November 12, 2015

Re: COPC Mapping White Paper – CPG Response — May 2007 Administrative Agreement and Order on Consent for Remedial Investigation/Feasibility Study – CERCLA Docket No. 02-2007-2009 (AOC)

RESPONSE TO REGION 2 WHITE PAPER ON CONTAMINANT MAPPING

LOWER PASSAIC RIVER STUDY AREA REMEDIAL INVESTIGATION/ FEASIBILITY STUDY

Figure 3-12d
Difference between Surface Concentration and Geomorphic Group Averages with Concentrations and Bathymetry for Reference Contaminant Mapping Response
Lower Passaic River Study Area Remedial Investigation/Feasibility Study

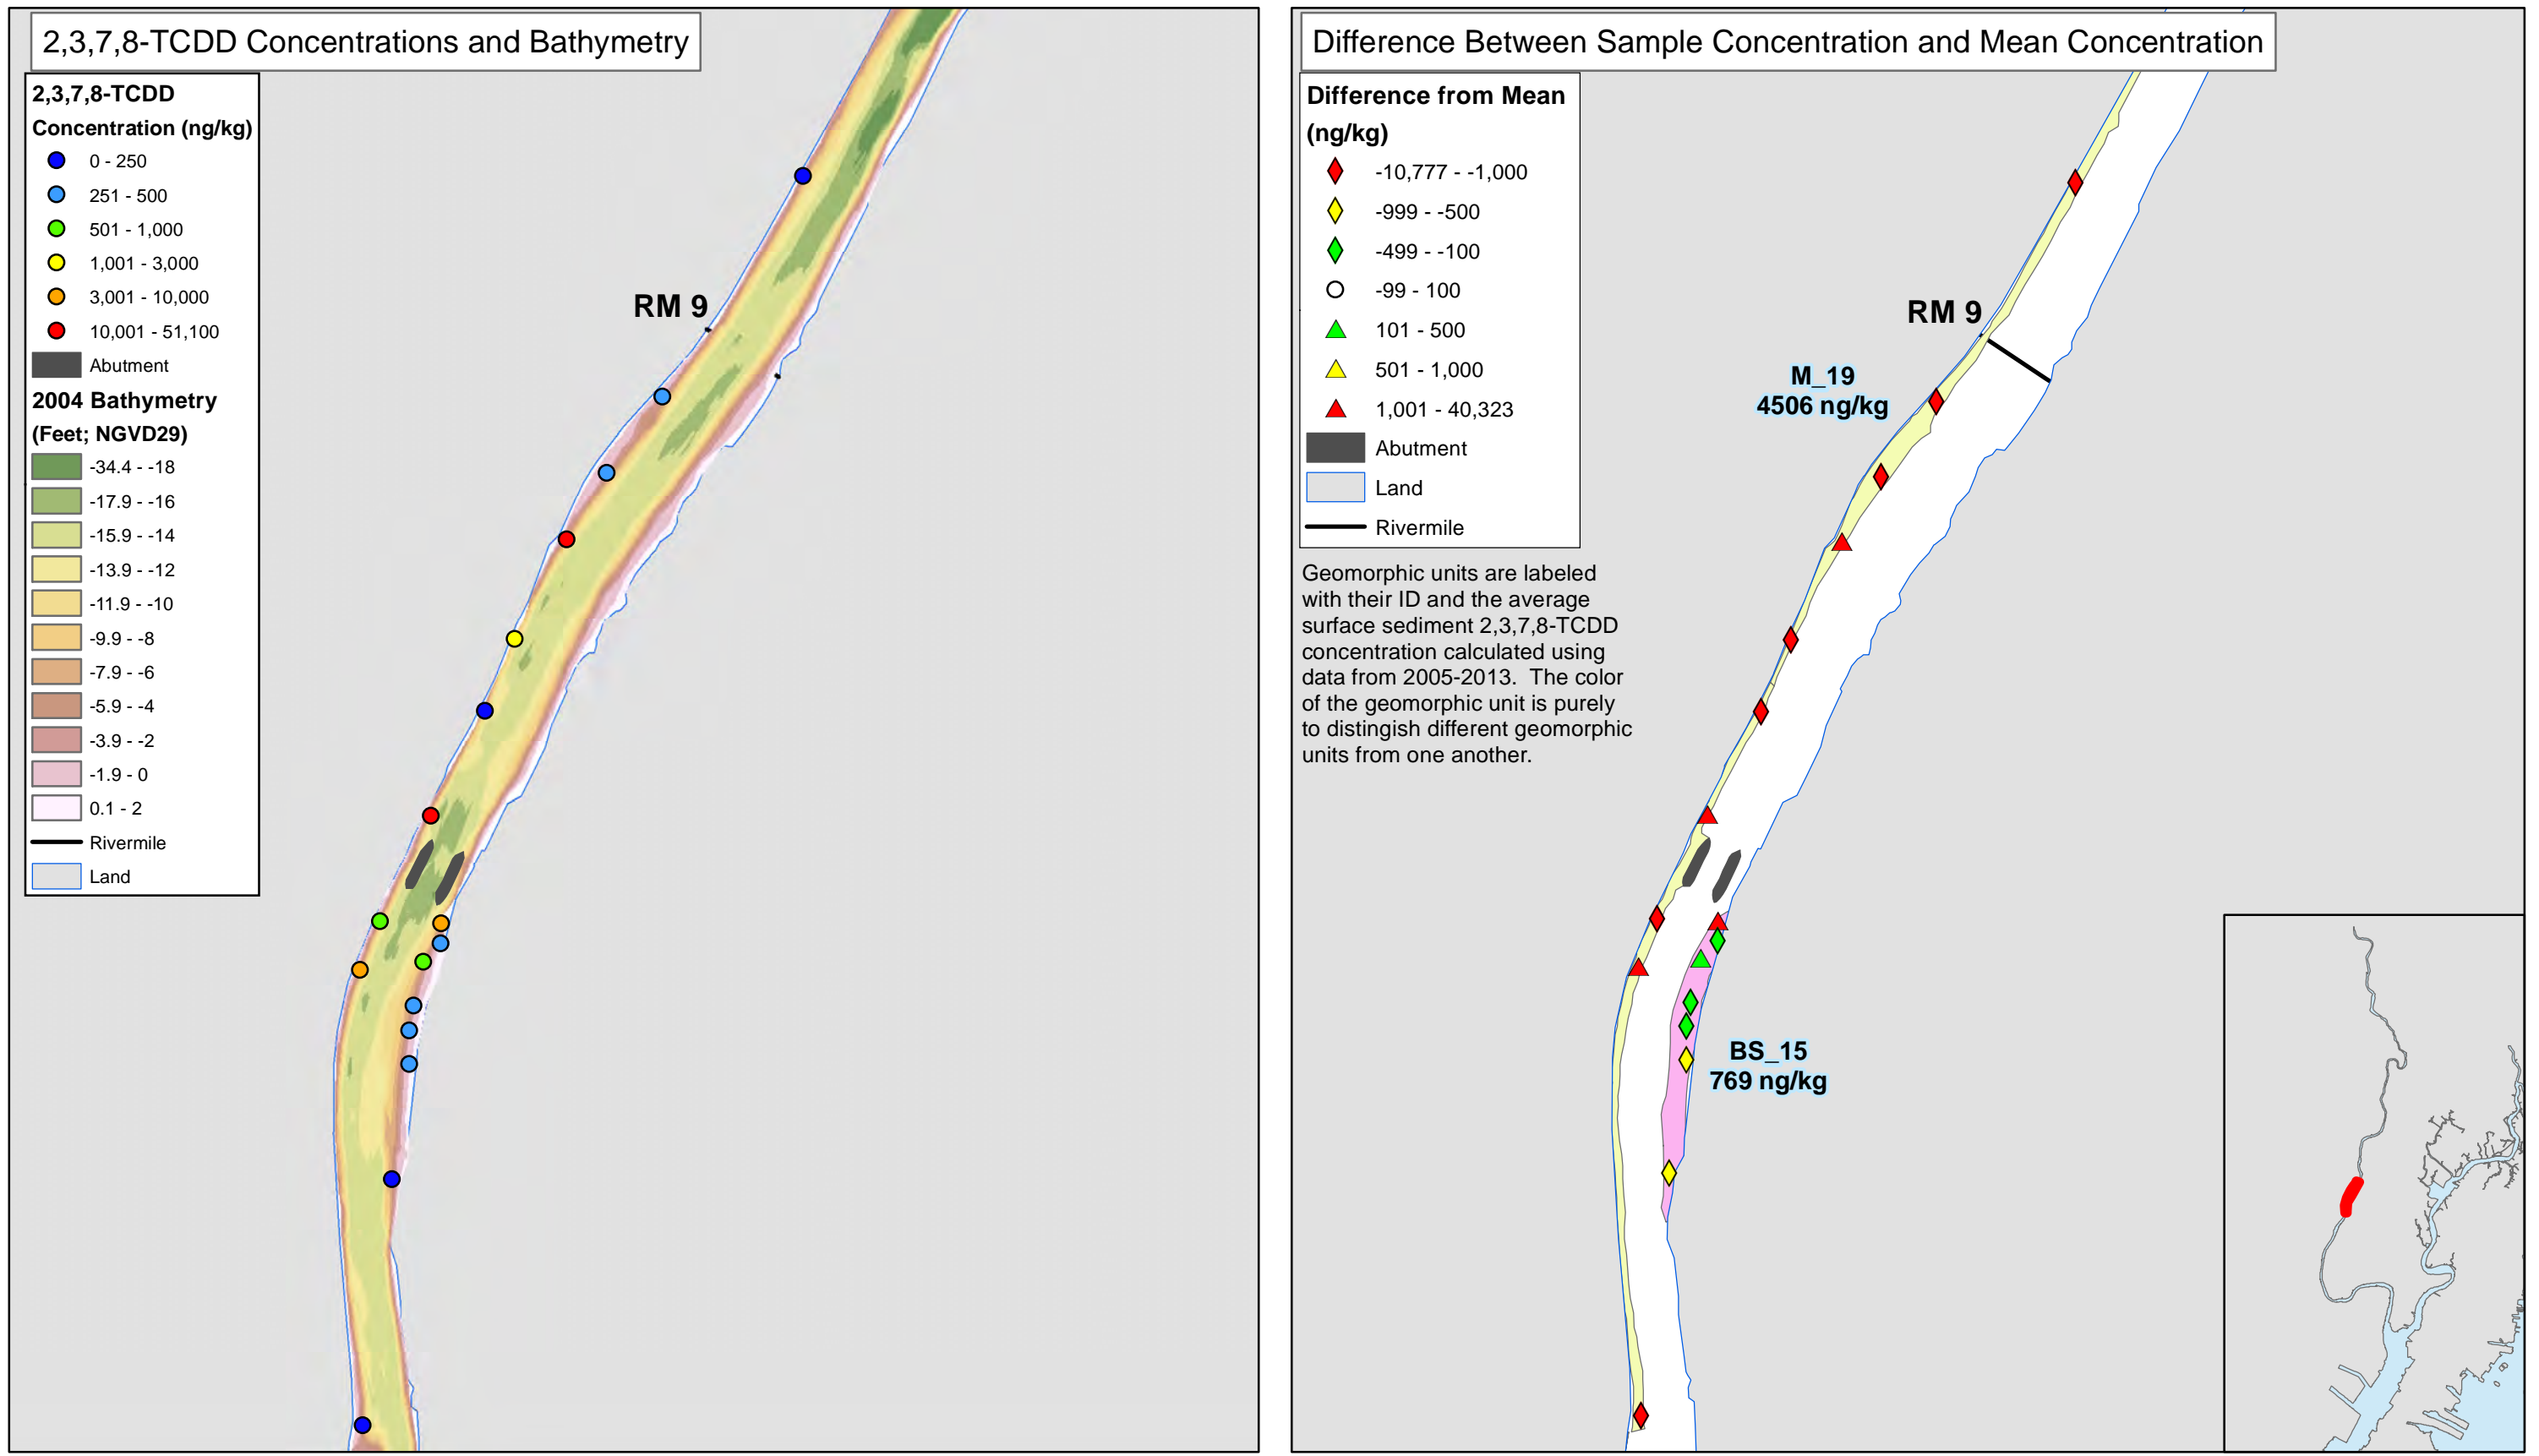
The stretch of the LPR between RMs 8 and 9 is presented in Figure 3-12d. The eastern and western shoals are parts of two geomorphic units. The eastern unit exhibits a clear spatial pattern with the highest concentrations in the northern portion next to the bridge abutment.

Figure 3-12h
Difference between Surface Concentration and Geomorphic Group Averages with Concentrations and Bathymetry for Reference Contaminant Mapping Response
Lower Passaic River Study Area Remedial Investigation/Feasibility Study

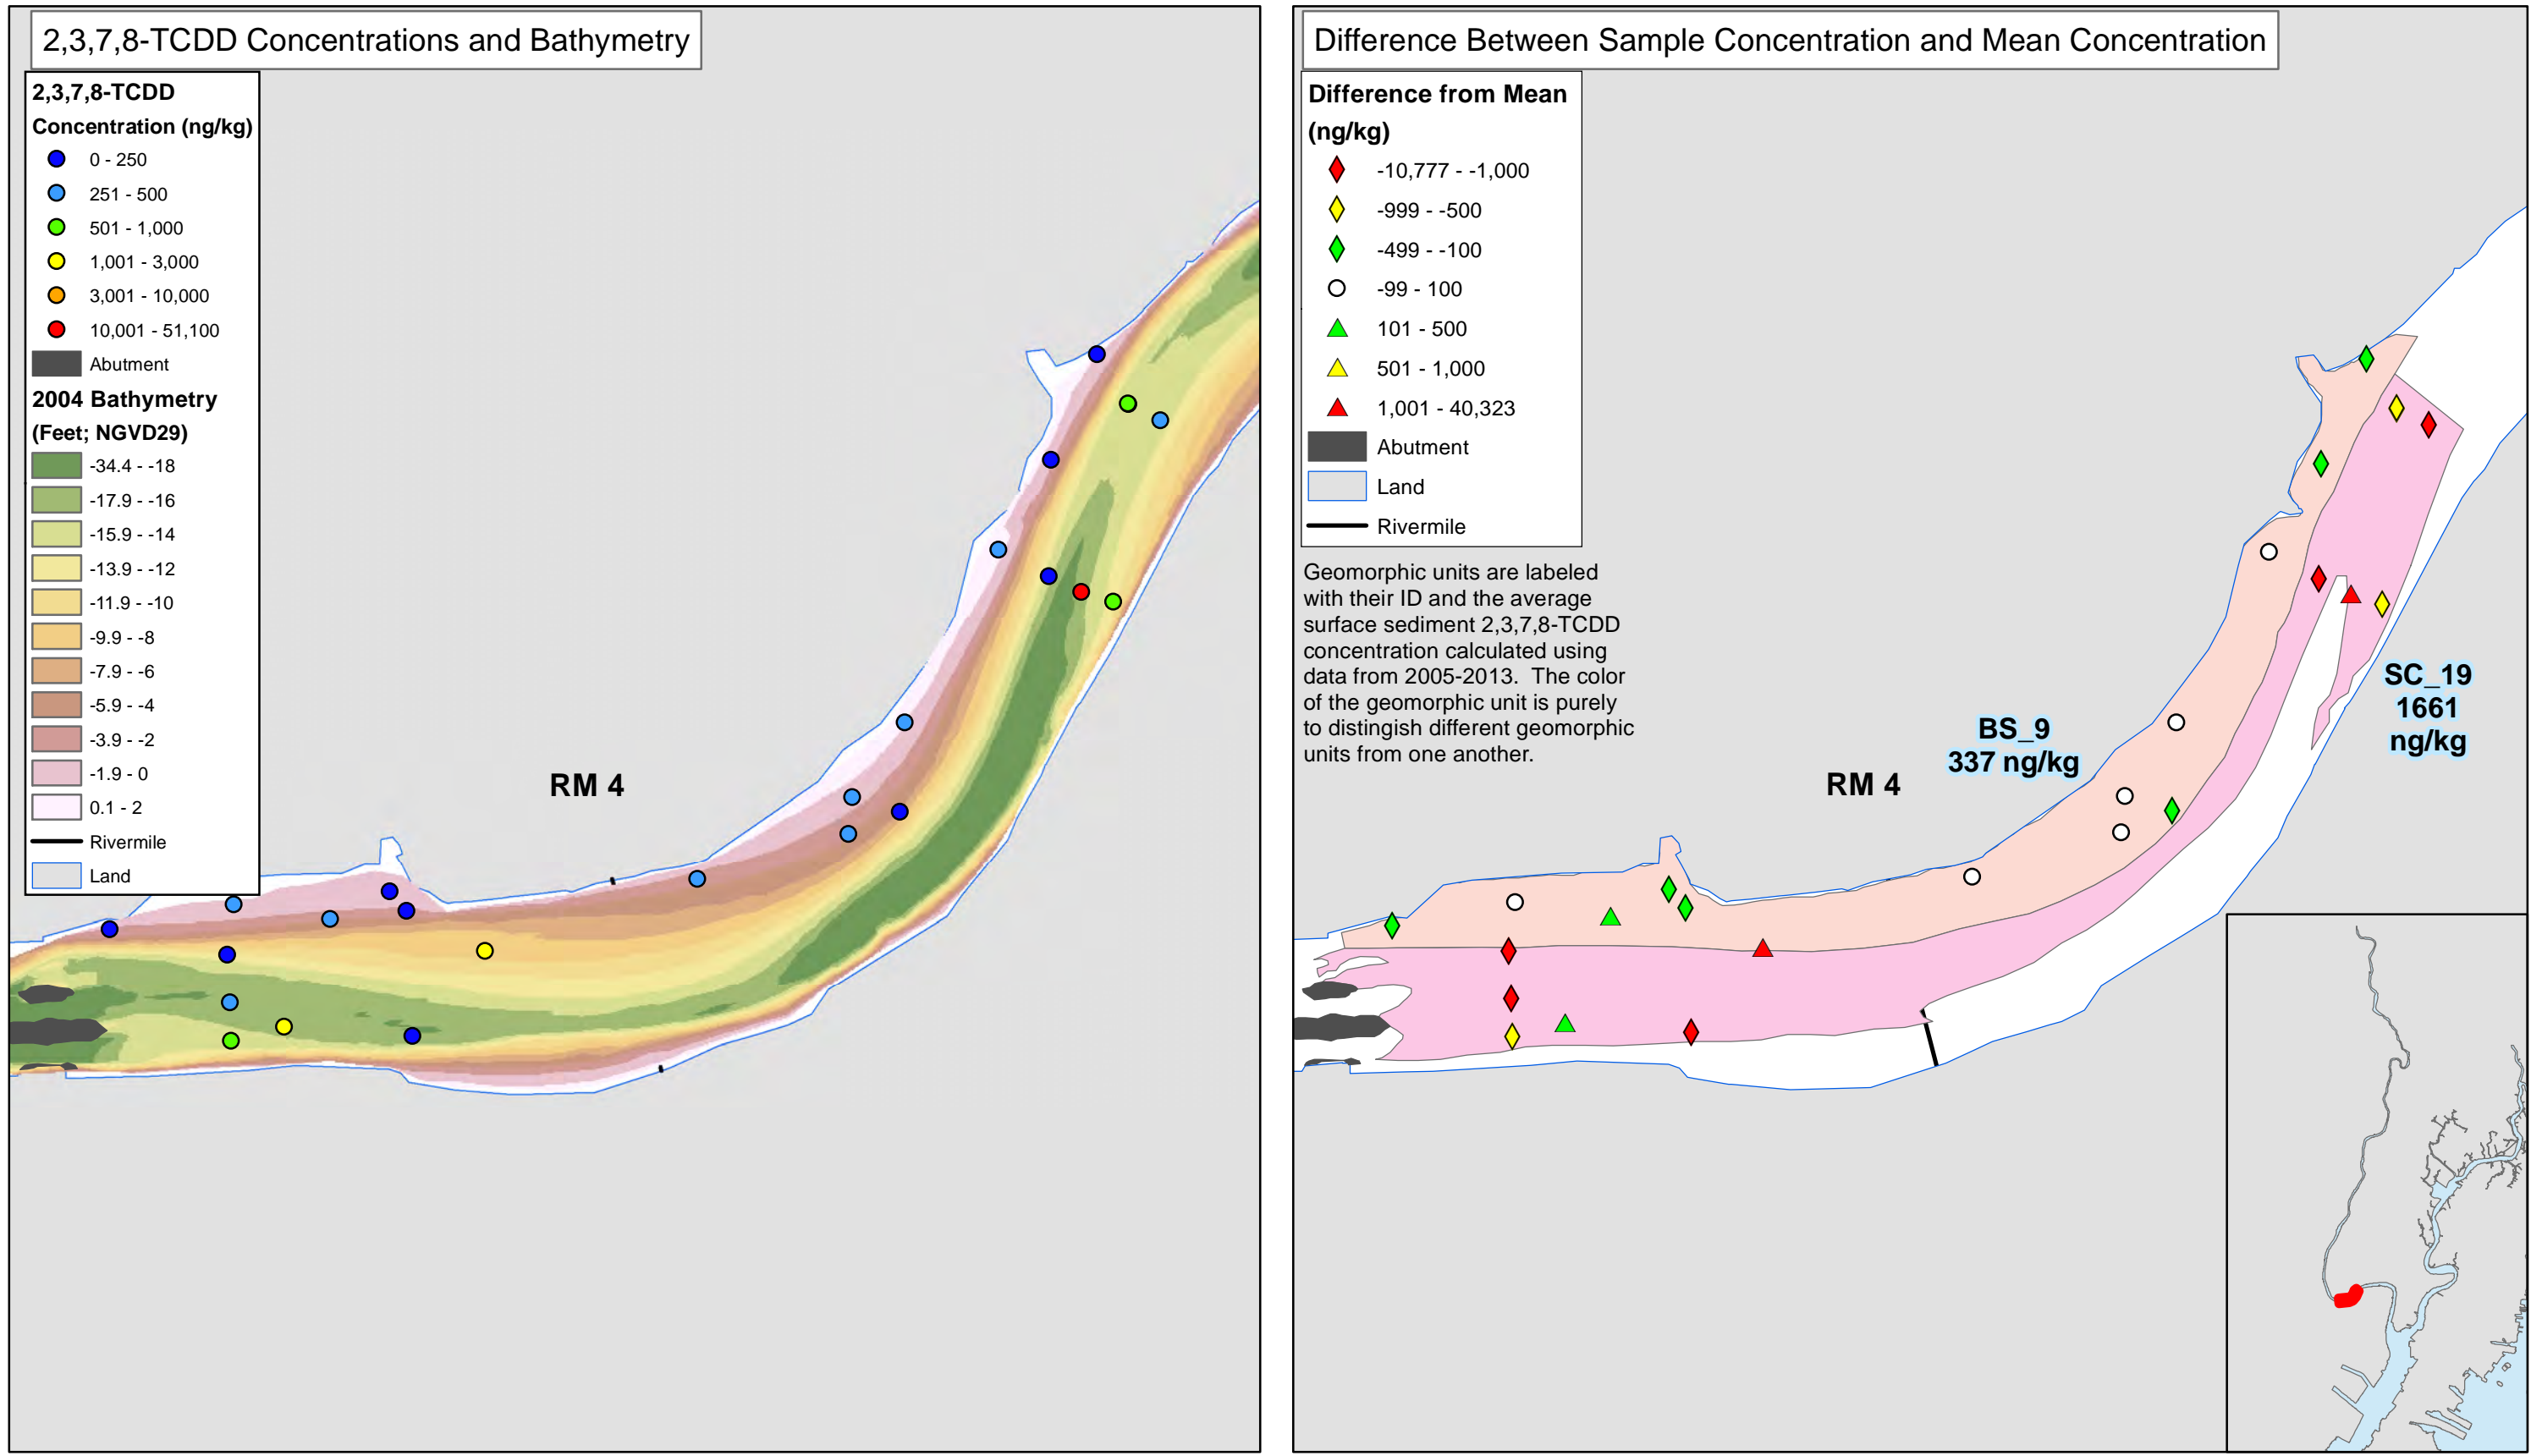
At RM 3.63, an elevated concentration in the middle of the channel results in an artificially high average concentration for the entire unit (Figure 3-12h). This elevated concentration, however, is because the sample was collected at a location that scoured during Hurricane Irene (see Sections 3.7 and 4.1 of the Draft 17-mile RI Report [Anchor QEA et al. 2015], which discusses this location in more detail). The surrounding sample locations did not scour during Irene, and this elevated point is not representative of the rest of the unit. The result of using the average is the misclassification of low contamination locations as highly contaminated.
